Agenda
Village of Arlington Heights
Design Commission
Community Room, 3rd Floor

Arlington Heights Village Hall
33 S. Arlington Heights Road
Arlington Heights, IL 60005
August 11, 2015
6:30 PM

STAFF DESIGN COMMISSION REPORT

Project Name: 131 S. Fernandez Ave.
Project Address: 131 S. Fernandez Ave.
Prepared By: Steve Hautzinger

LEFT ELEVATION

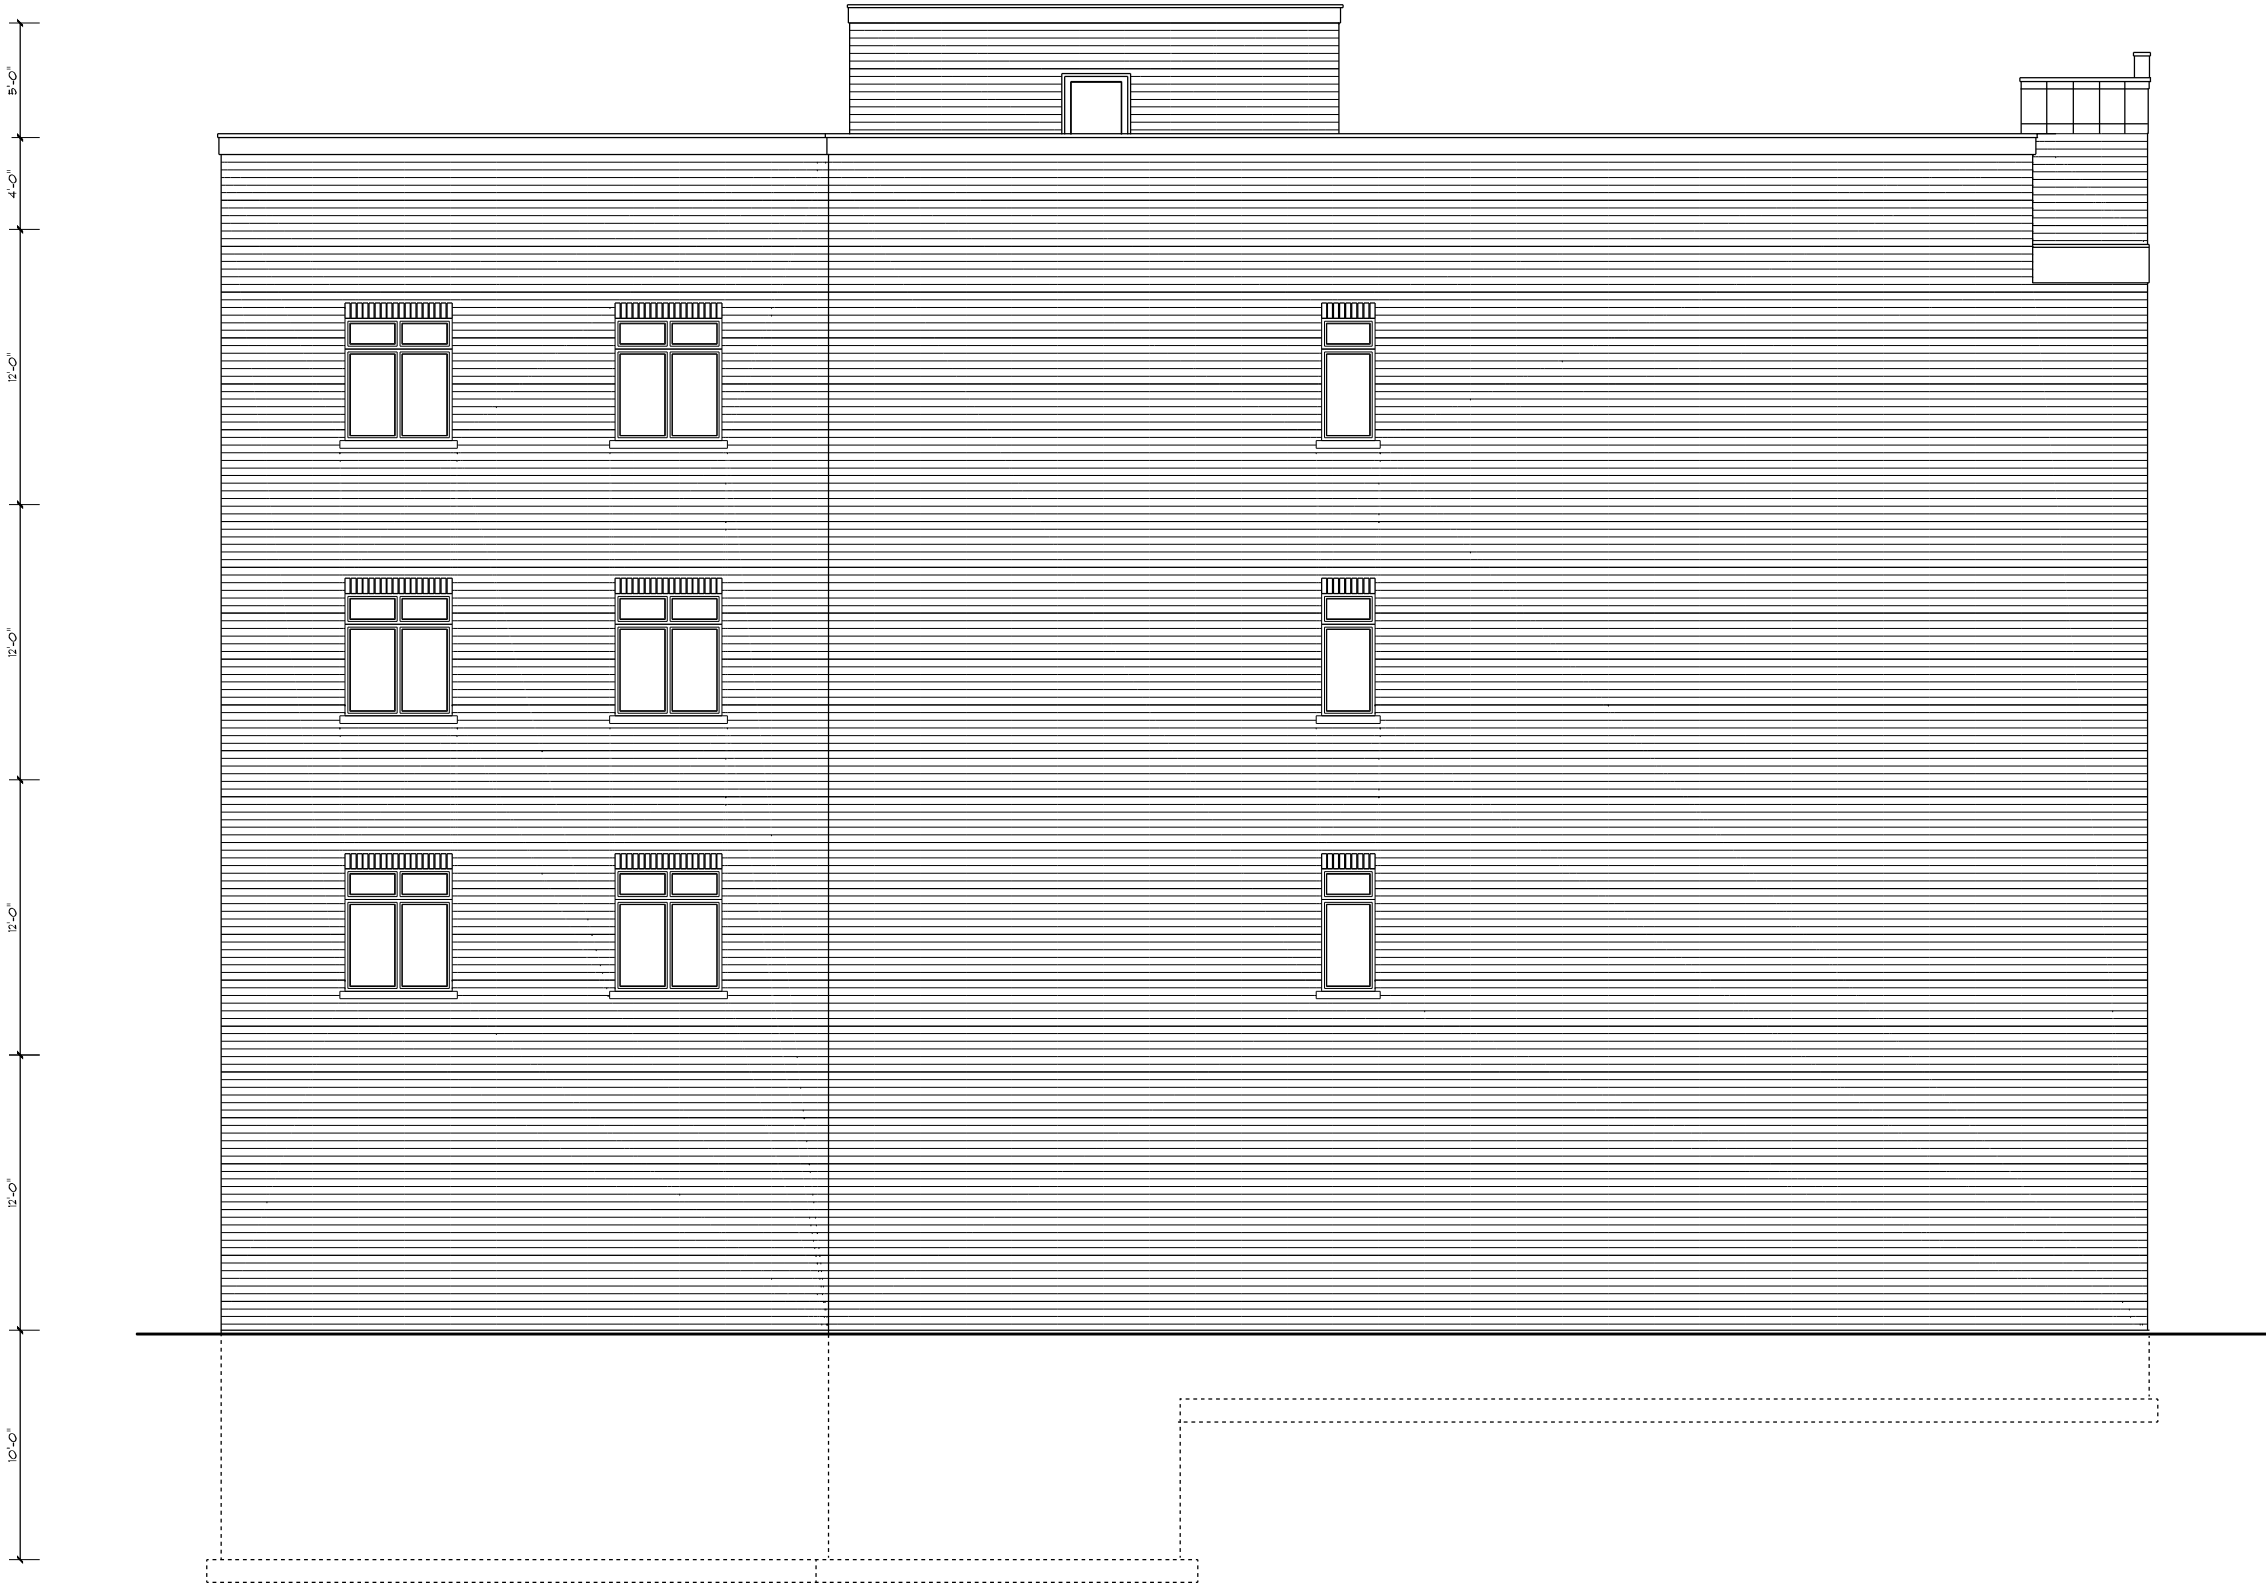
1. Consider continuing the roof deck railing detail from the front elevation down the side elevations.
2. Preliminary building code review concludes that the three windows shown on the left (east) elevation are not allowed due to fire separation requirements where the wall is not set back from the lot line. Consider adding more brick and stone detailing to add interest to this large blank wall.
3. The front half of the right (west) elevation is set back eight feet from the property line and will be highly visible. Consider opening the side of the balconies as well as adding windows on this wall.
